Windshield Wiper Arm with Replaceable Washer Nozzle

M-363-001

(January 2008)

Mack CXU,CHU,GU built before August 2007

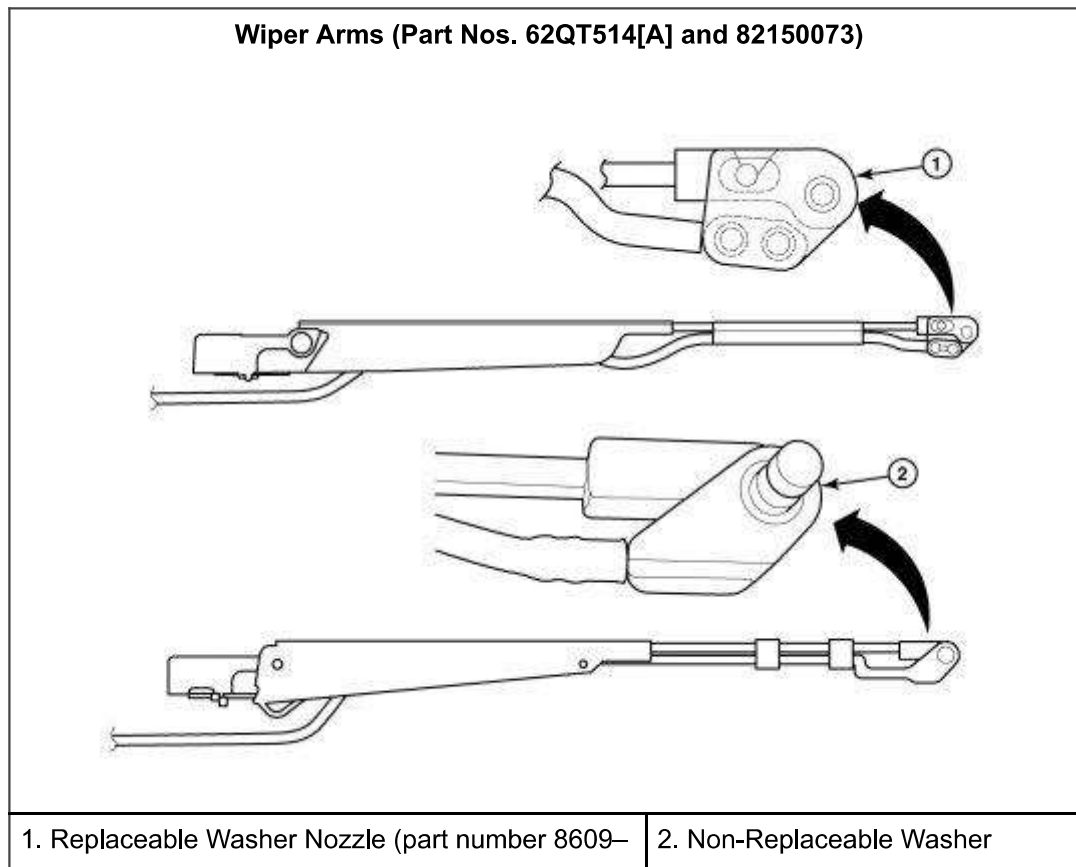
Beginning August 2003 through July 2007, windshield wiper arms with non-replaceable windshield washer nozzles were used in production on all conventional model chassis(CXU, CHU, GU, CXP, CXN, CX, CTP, CT, CHN, CH, CV and CL). Effective August 2007, a windshield wiper arm having a replaceable windshield washer nozzle was implemented into production.

If a windshield washer nozzle assembly must be replaced, it is first necessary to determine which wiper arm is being serviced. Wiper arm part number 62QT514(A) utilizes non-replaceable washer nozzles. If this is the case, the wiper arm must be upgraded to wiper arm part number 82150073 which utilizes the replaceable washer nozzles. With this wiper arm, the nozzles can then be serviced at a later time if required.

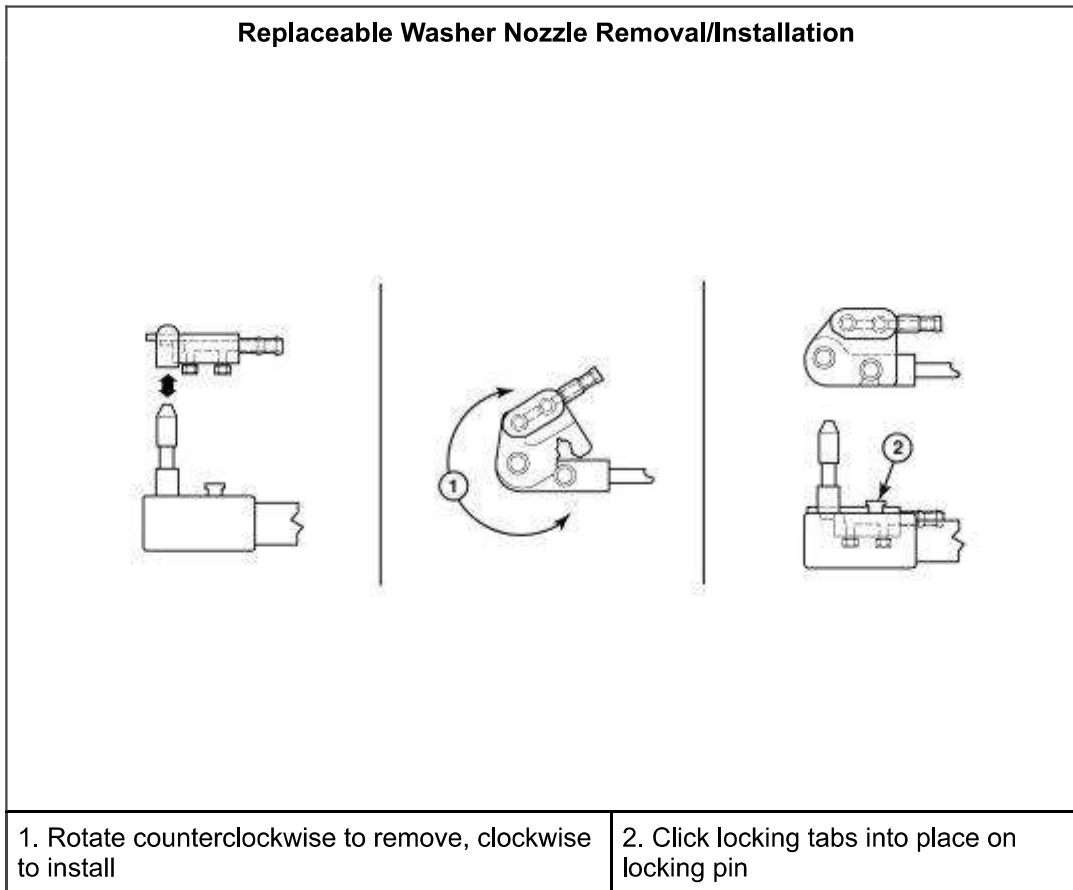
80014221), used with wiper arm part number 82150073

Nozzle (wiper arm part number 62QT514[A])

1. Remove the wiper from the wiper arm assembly.
2. Disconnect the hose from the washer nozzle holder.
3. Rotate the nozzle holder assembly counterclockwise until the locking tabs are released from the locking pin.
4. Slide the washer nozzle holder off the wiper blade shaft.
5. Install the replacement nozzle assembly (part number 8609–80014221) using the reverse procedures of removal.
